4th December 2017

Application no. 2017 / 507 / P
ORT House, 126 Albert Street

South facing elevation wall on which it is proposed to insert
4 large bay windows. Taken from 1st floor window in adjacent
property 118 Albert Street. 3rd Dec 2017.

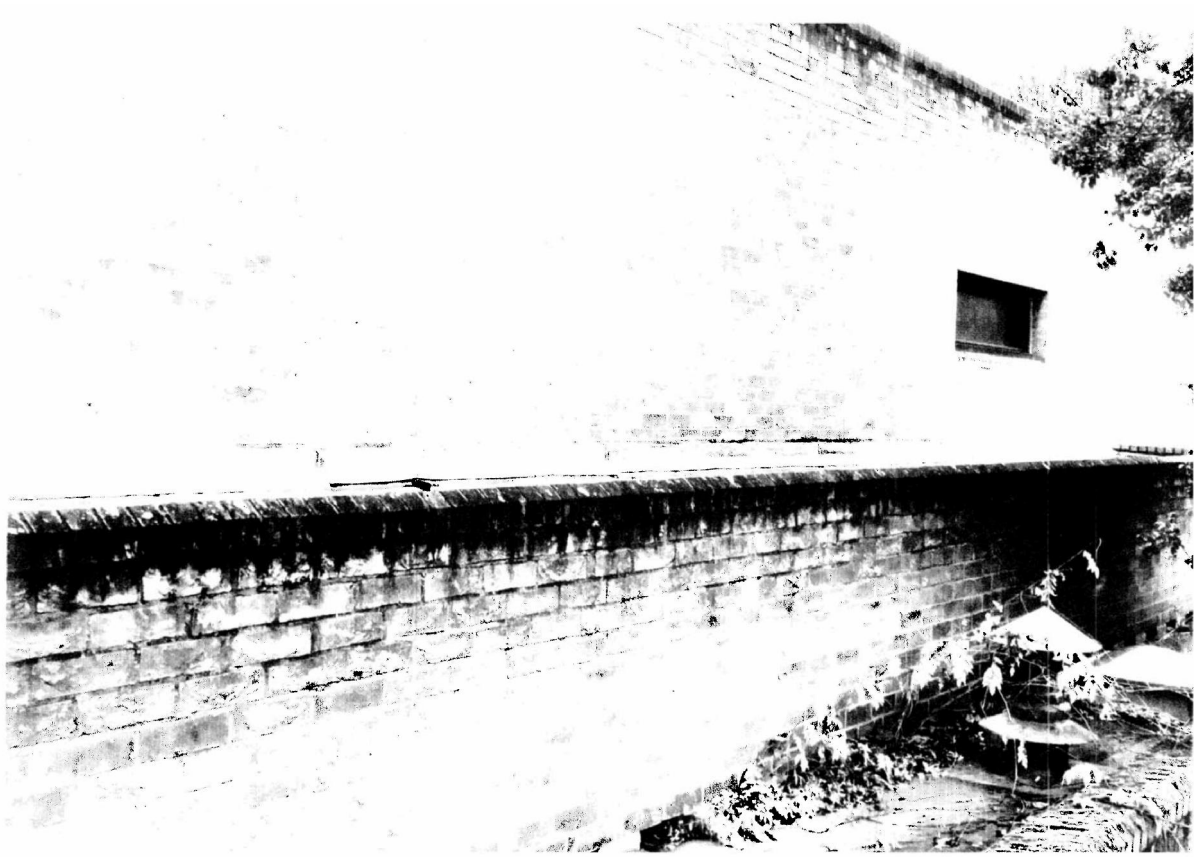
Drawing no. PA 11 shows projected bay windows. It is not clear what the south facing part is made of - is this made of solid material or 'opaque glass'? What will it look like? Are the side projections made of opaque glass? It appears that the apertures which look towards the east elevation of the buildings in Albert Street are would overlook us. The drawings as they stand do not answer these questions. It looks as if this part of the building has a flat roof and, if it is purely a matter of light requirement, why not use roof lights. These would not need to be opaque and would admit plenty of light without any potential of overlooking. If fixed opaque windows are permitted how can we be sure that these assurances will not be breached at a further date?

1. A copy of the letter written by the original architect Anthony Furlong from Shepherd Robson in 2000 when the previous application was made.
2. A copy of the refusal letter from the planning committee with reasons for their decision.
3. A photograph of the rear south facing wall at present. This is no more than approximately 8ft from my windows where the applicants are proposing 4 large bay windows with unclear specification of materials and opacity.
